Access Compliance Report

Public Rights-of-Way

(Curb Ramps)

Intersection ID: 3171	Main Street: ROBYNS_GLEN_DR	Cross Street: SONG_SPARROW_LN	Location: W
ADA ID: B6E95B183B48	Ramp Type: Perp	Initial Pass/Fail: Fail	Overall Compliance: No
Codes/Mitigation Info/Possible Solution		Field Measurements/Component Compliance	
Severity Score: 26.25

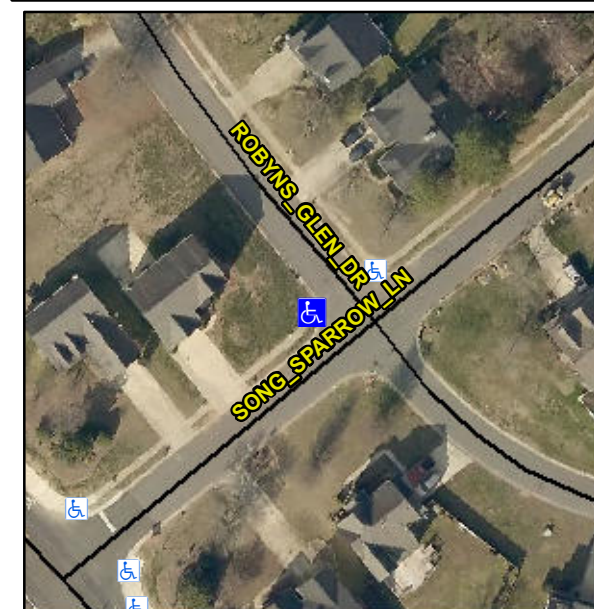
R304.2.2, R304.5.3

Compliance	Description	Data	Compliance	Description	Data
N/A	Ramp Length (in)	48.0	No	Ramp Slope (%)	12.5
Yes	Ramp Width (in)	72.0	No	Ramp XSlope (%)	2.9
N/A	Flare Type LT	N/A	N/A	Flare Type RT	N/A
N/A	Flare Slope LT (%)	N/A	N/A	Flare Slope RT (%)	N/A
N/A	Flare Traversable LT?	N/A	N/A	Flare Traversable RT?	N/A
N/A	Landing Length (in)	N/A	N/A	DWS Provided?	N/A
N/A	Landing Width (in)	N/A	N/A	DWS Contrast?	N/A
N/A	Landing Slope (%)	N/A	N/A	DWS Length (in)	N/A
N/A	Landing X Slope (%)	N/A	N/A	DWS Full Width?	N/A
N/A	Landing Curb? (Y/N)	N/A	N/A	DWS Offset (in)	N/A
N/A	Shared Landing?	N/A			
N/A	Gutter Ponding?	Yes	N/A	Gutter Slope (%)	N/A
N/A	Gutter Lip Ht (in)	N/A	N/A	Gutter X Slope (%)	N/A
N/A	Painted X Walk1?	No	N/A	Painted X Walk2?	N/A
	X Walk 1 Direction	To NE		X Walk 2 Direction	N/A
N/A	X Walk 1 Width (in)	N/A	N/A	X Walk 2 Width (in)	N/A
	X Walk 1 Slope (%)	0.3		X Walk 2 Slope (%)	N/A
	X Walk 1 X Slope (%)	1.0		X Walk 2 X Slope (%)	N/A

Remove & Replace Entire Ramp.
